Technical Audit–Due Diligence Report (Loan 2257-AFG: North-South Road Corridor Project)

Due Diligence Report

Contract Number S19303

Loan 2257 North-South Corridor Road Project

Figure 1 - Feasibility Study vs Contractor's Survey and Design

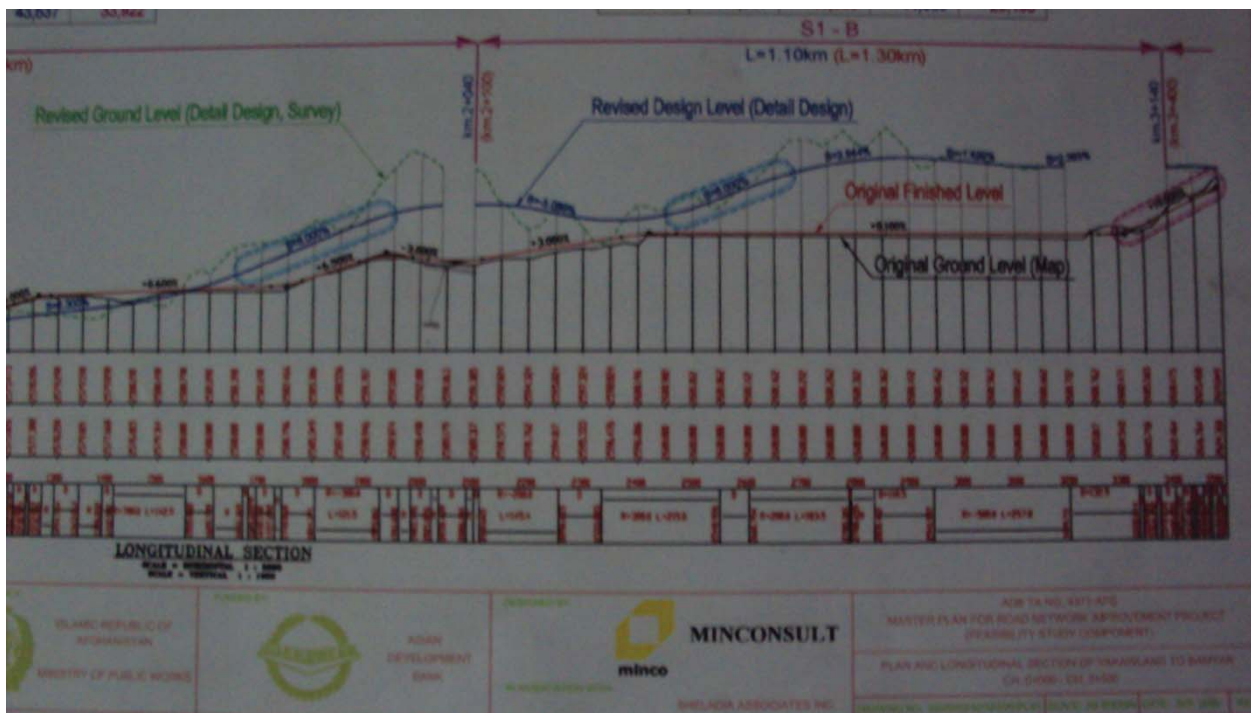
The survey provided with the Feasibility Study was not accurate enough to provide accurate earthwork quantities for the Contract bid. The figure below shows the situation graphically. In essence, the survey

data did not show all of the elevation changes that were found when the Contractor did a detailed survey. The Contractor is entitled to the costs associated with increased quantities arising from their more accurate survey. The Contractor's design also deviates significantly from the existing alignment in many cases, which is the primary source of the large quantity changes in Variation Order One.

Figure 2 - Costly Alignment Change

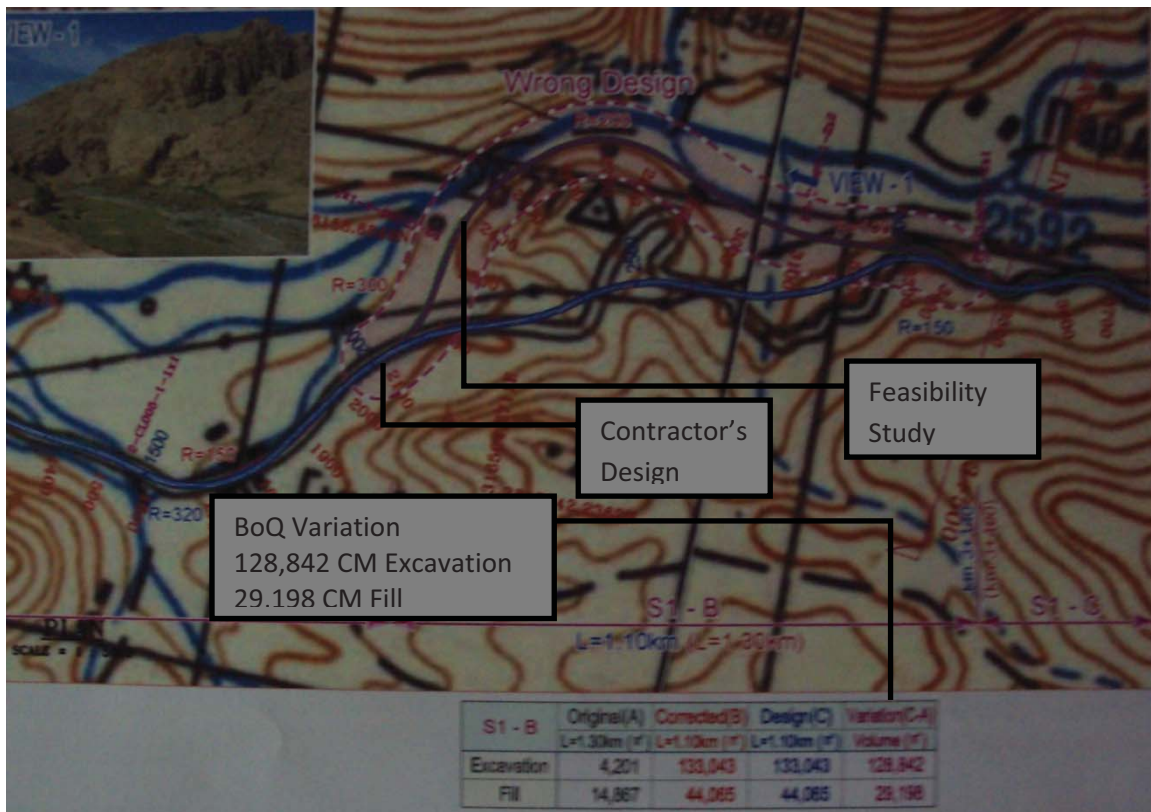
In a January 20, 2009 letter the Deputy Minister of Public Works directed the Contractor to revise the design to show a minimum curve radius of 80M to save on costs. The Contractor's current design does not reflect MPW's direction. In some cases this substantially increases the cost of a particular road section. In other cases the cost is the same or lower. The figure below shows a situation in which the Contractor's designer could have reduced costs by hugging the natural contours and reducing the cost of the road section while producing a compliant design.

Note that the changes shown in the variation cost \$884,774. The alignment shown as “wrong design” is not as attractive as the alternative alignment chosen by the Contractor, but the change is not justified when considering the additional expense associated with this 1KM section of road and the clear direction of the Deputy Minister. These situations along the alignment are the primary source of potential cost savings indicated in this report. It should be noted that most of the cost-avoidance that was possible at the design stage (early 2009 timeframe) cannot be recovered for Contract 3. The Contractor has accelerated excavation work on ICB3 throughout the spring, summer, and fall of 2009 such that most of the unapproved excavation is complete. It is important to note that at the same time

Figure 3 - One example of the contractor's design basis for the rejected change order

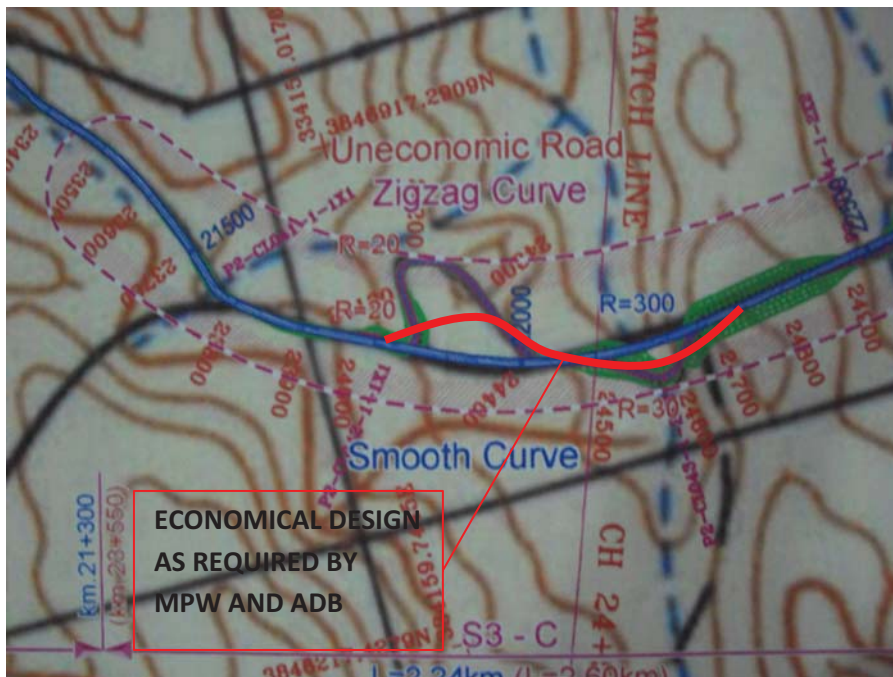
Samwhan requested adjustments to the original BoQ for Contract 3 based on the design changes from the grades that were shown in the Feasibility Study. At the same time, Samwhan also made significant changes in the road's alignment in the revised design that significantly increased the excavation and fill quantities. In some cases the resulting design increased the required excavation and fill quantities by an order of magnitude. The proposed changes in the BoQ were not accepted by MPW and ADB. The table below shows the potential impact of following the original road alignment more closely, following the directive to economize the alignment by using a minimum horizontal curve radius of 80M. The table below covers approximately 60% of the 2257 ICB3 Alignment. Estimated savings for the reviewed portion of Contract 3 are \$4,182,137 USD. Projecting the reviewed data across the remainder of Contract 3 and including Contracts 1 and 2, a conservative estimate of total potential savings for all 3 packages was \$6.5MUSD.

The proposed changes in the BoQ were not accepted by MPW and ADB (see attached correspondence).
